NCR Number: HSO-CDF-NCR-100

Spacecraft / Project	Herschel	Originator's Name	Peter Hargrave	
Experiment / Model	SPIRE / PFM	Signature		
Sub-System	300mK strap support system LTS-PFM-000	Date	June 29 th 2005	
Assembly	300mK photometer light baffle	Level (Highlight if applicable)	Major	Minor
Sub-Assembly				
Item		NRB Reference		
Serial Number	LTS-PFM-400

NCR Title	Difficulty fitting light baffle to photometer box
------------------	---

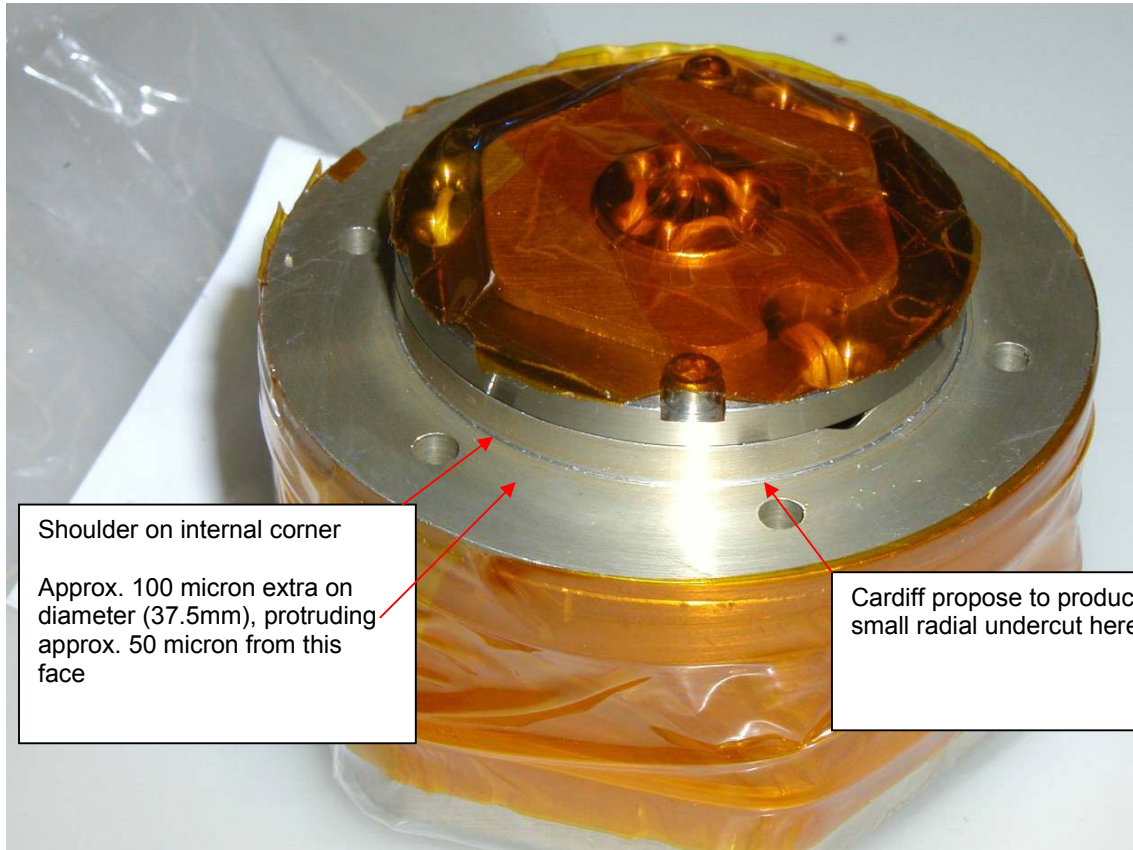
Close inspection revealed a very small "shoulder" at the inner corner of the light baffle / photometer box interface (see attached figure). This is due to the difficulty in producing a perfectly square inner corner, which requires very careful machining and very carefully ground turning tools.

Shoulder on internal corner

Approx. 100 micron extra on diameter (37.5mm), protruding approx. 50 micron from this face

Cardiff will undertake to produce a small undercut at this interface, to compensate for the lack of the chamfer. This is because, at the time of writing, the photometer box is ~90% integrated, and modifying the light baffle is less upheaval overall.

Cardiff propose to produce very small radial undercut here
